CITY OF PORTLAND BUILDING PERMIT

Job ID: 2012-08-4806-ALTR

has permission to Amend permit; putting in a spiral stair case

Jonathan Rioux - RE: Fwd: Lennox 25 House - Spiral Stair Floor Framing Details

CSK-5

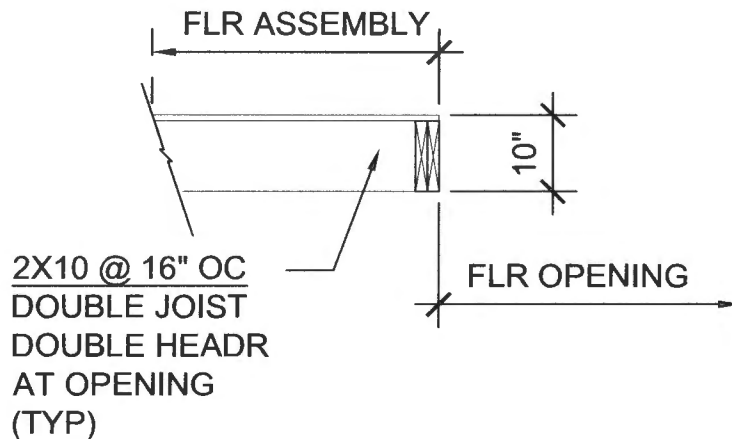
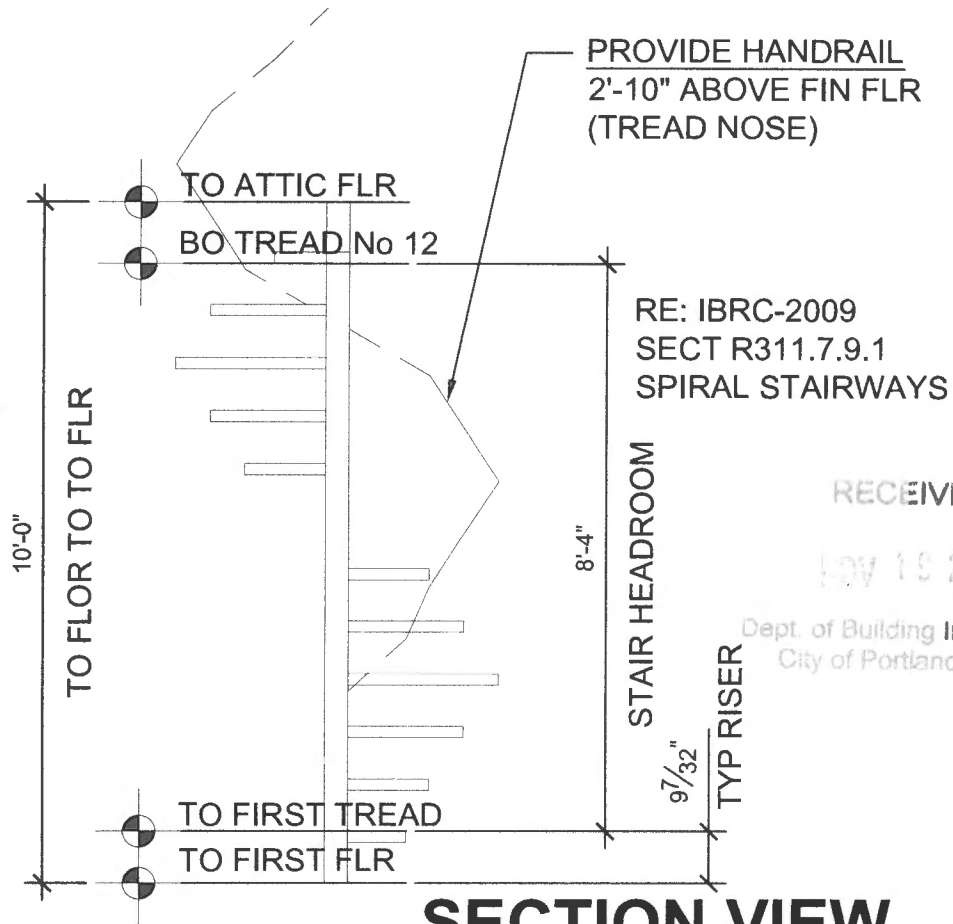
- What did you design the live load for the "attic storage" area?
- Is there an emergency escape for the habitable attic area?

R502.3.1 Sleeping areas and attic joists. Table R502.3.1(1) shall be used to determine the maximum allowable span of floor joists that support sleeping areas and attics that are accessed by means of a fixed stairway in accordance with Section R311.7 provided that the design live load does not exceed 30 pounds per square foot (1.44 kPa) and the design dead load does not exceed 20 pounds per square foot (0.96 kPa). The allowable span of ceiling joists that support attics used for limited storage or no storage shall be determined in accordance with Section R802.4.

ATTIC, HABITABLE. A finished or unfinished area, not considered a story, complying with all of the following requirements: 1. The occupiable floor area is at least 70 square feet (17 m²), in accordance with Section R304, 2. The occupiable floor area has a ceiling height in accordance with Section R305, and 3. The occupiable space is enclosed by the roof assembly above, knee walls (if applicable)

SECTION R310 EMERGENCY ESCAPE AND RESCUE OPENINGS R310.1 Emergency escape and rescue required. Basements, **habitable attics** and every sleeping room shall have at least one operable emergency escape and rescue opening...

- LL=40 psf (SPF #2 or better) (2x10 @16 OC w/ DL = 10psf)
- Yes, emergency escape is provided (second story/glazed window). The primary occupancy use of the Attic area is storage for Mr. Brown's artwork. Furthermore, it's my understanding that the new house will be fully sprinklered in accordance with NFPA-13R as required by the City's FP rules. Note: By building code ruling, Emergency escape is except for habitable spaces when the building is sprinklered, nevertheless windows are being provided at two sides: a)one unit at end gable wall (approx. 3x5 ft RO size window) and a triple dormer wall (approx. 9x3 ft RO size window)

CSK-2

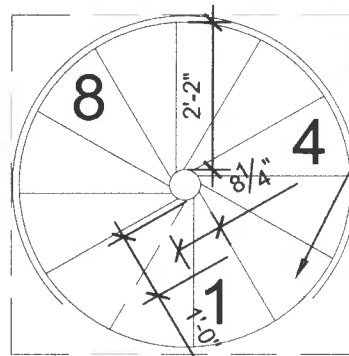
3. R311.7.9.1 Spiral stairways. Spiral stairways are permitted, provided the minimum clear width at and below the handrail shall be 26 inches with each tread having a 7 1/2-inch minimum tread depth at 12 inches from the narrower edge. All treads shall be identical, and the rise shall be no more than 9 1/2 inches. A minimum headroom of 6 feet 6 inches (1982 mm) shall be provided.
